CABLE ASEMBLY
MODEL MT2A

DRAWING CHANGE NOTICE

DRAWING NO. 603933 | REV. B

DCN NO. 3258

SIZE	CODE IDENT. NO.	DWG. NO.	REV.
B	52158	*603933*	*B*

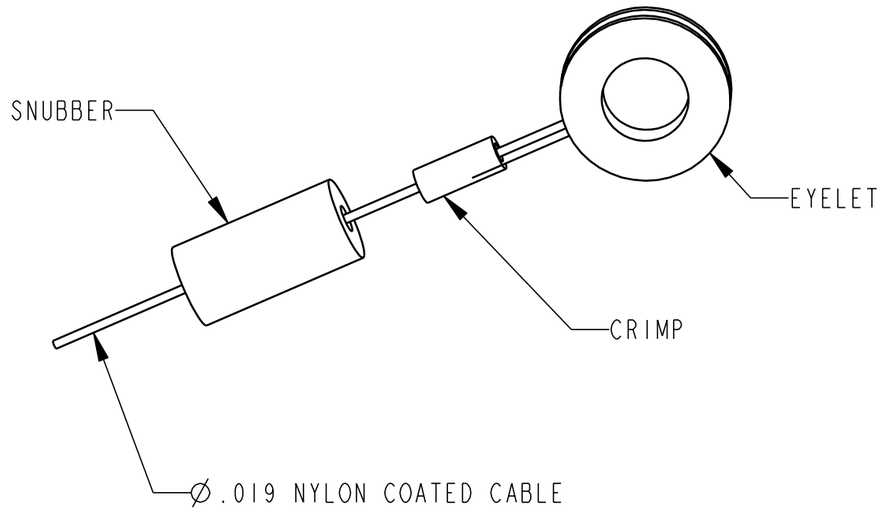
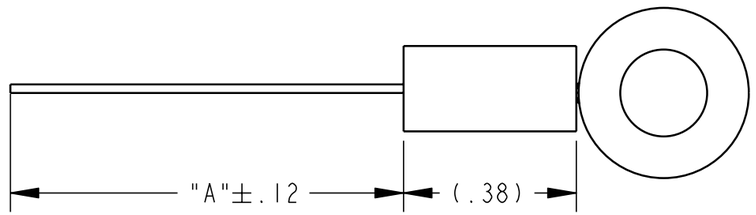
CHANGE NO.	REVISED OR CHANGED FROM	ZONE	ADDED OR CHANGED TO
1	5		4.5
2	11		10.37
3	17		16.50
4	32		31.50
5			
6			
7			
8			
9

REASON: THE LENGTH OF THE CABLE WAS INCORRECT.

RANGE	"A"
3	4.50
9	10.37
15	16.5
30	31.5
